Project	IEEE 802.16 Broadband Wireless Access Working Group < http://ieee802.org/16 >
Title	Proposed text and ASN.1 code to support MOB_PAG-ADV
Date Submitted	2007-03-09
Source(s)	Joey Chou Intel Corporation [mailto:joey.chou@intel.com]
Re:	
Abstract	This contribution proposes the text and ASN.1 code in wmanIf2mMib to support MOB_PAG-ADV message.
Purpose	Adoption
Notice	This document has been prepared to assist IEEE 802.16. It is offered as a basis for discussion and is not binding on the contributing individual(s) or organization(s). The material in this document is subject to change in form and content after further study. The contributor(s) reserve(s) the right to add, amend or withdraw material contained herein.
Release	The contributor grants a free, irrevocable license to the IEEE to incorporate material contained in this contribution, and any modifications thereof, in the creation of an IEEE Standards publication; to copyright in the IEEE's name any IEEE Standards publication even though it may include portions of this contribution; and at the IEEE's sole discretion to permit others to reproduce in whole or in part the resulting IEEE Standards publication. The contributor als

Figure 19—wmanlf2mBsCm structure

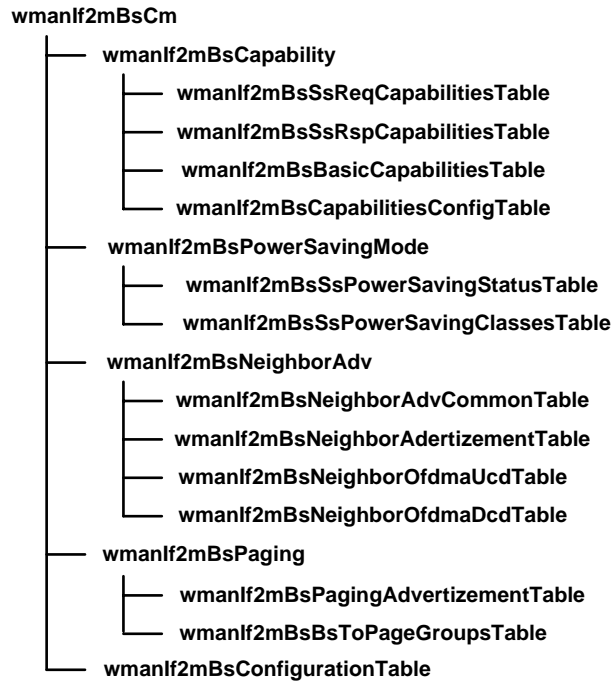
[Change Figure 19 as the following:]
